SUBJECT: Third Six-Month Status Report in Response to March 12, 2012,  
Commission Order Modifying Licenses with Regard to Reliable Spent  
Fuel Pool (SFP) Instrumentation (Order Number EA-12-051)  
Arkansas Nuclear One – Units 1 and 2  
Docket Nos. 50-313 and 50-368  
License Nos. DPR-51 and NPF-6

**Arkansas Nuclear One (ANO) Units 1 and 2 (ANO-1 and ANO-2) Third Six Month  
Status Report for the Implementation of Order EA-12-051, Order to Modify  
Licenses with Regard to Reliable Spent Fuel Pool (SFP) Instrumentation**

Attachment 2  
ANO Unit 2 – SFPI Simplified Spent Fuel Pool Instrument  
Approximate Locations and Approximate Cable Routing

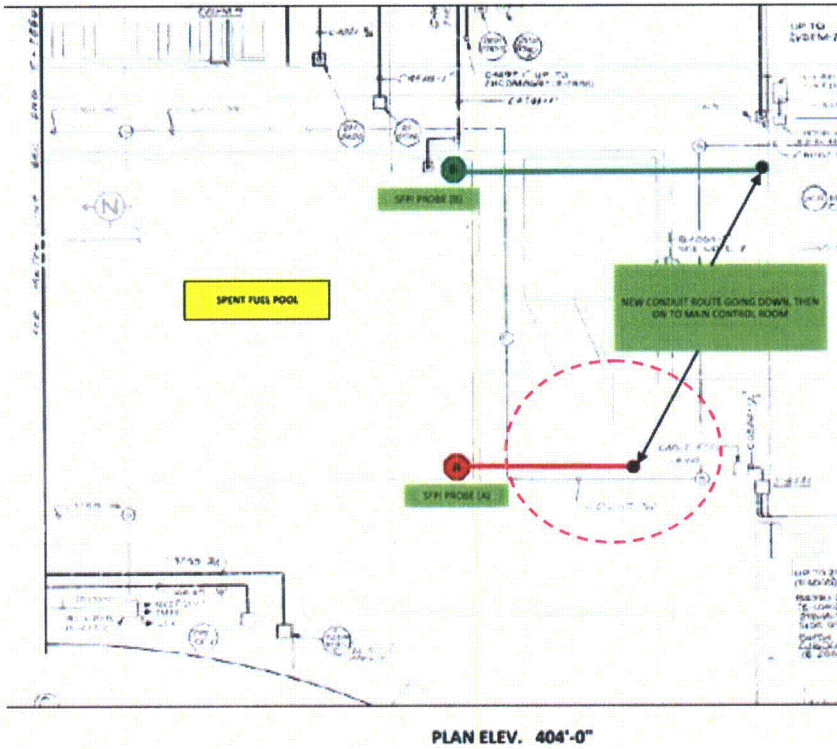
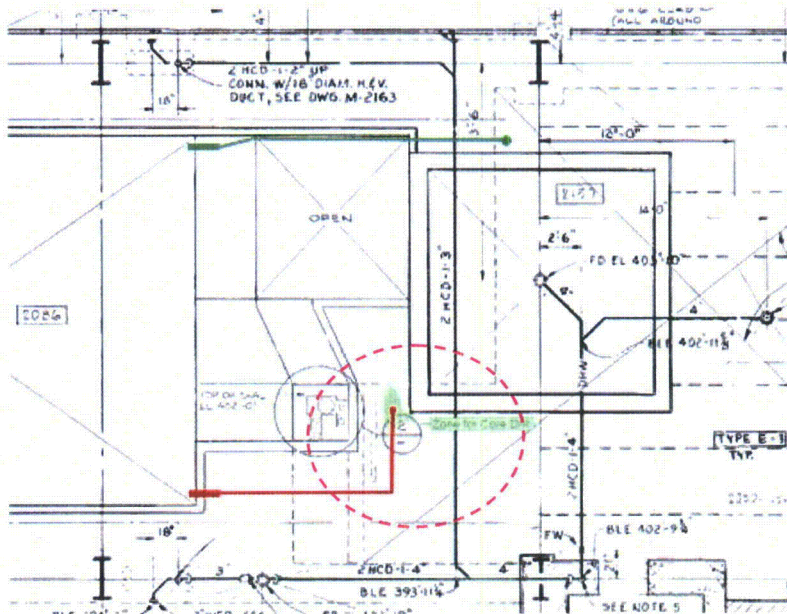
OIP (Reference 1) Attachment 2 (ANO Unit 2 – SFPI, Approximate Sensor Location and Approximate Cable Routing) is updated relative to Channel A cable routing. See Figure 1 and Figure 2. Original showed sensors located in opposite corners of the SFP's short side (which is not changed) with the cable routing from the sensors proceeding due south and maintaining the same relative sensor spatial separation out to the floor penetrations (which is changed). Channel A floor penetration location (and related cable routing) is revised due to interference on the elevation below. The change brings the Channel A cable routing closer to the opposite channel (i.e., spatial separation is less than the SFP's short side). However, substantial and adequate spatial separation is maintained ( $\approx 3/4$  of that original planned). Also, unchanged is the reasonable protection provided by seismically mounted protective metal raceway and additional protection afforded by objects in the vicinity which rise above the floor grade (e.g. SFP curbs and/or SFP bridge tracks/rails). Information associated with the NRC RAI #4.a (Reference 6) response and information preceding NRC ISE RAI #11 (Reference 3) discusses cable routing maintaining the same relative sensor spatial separation and, as such, is impacted and also updated.
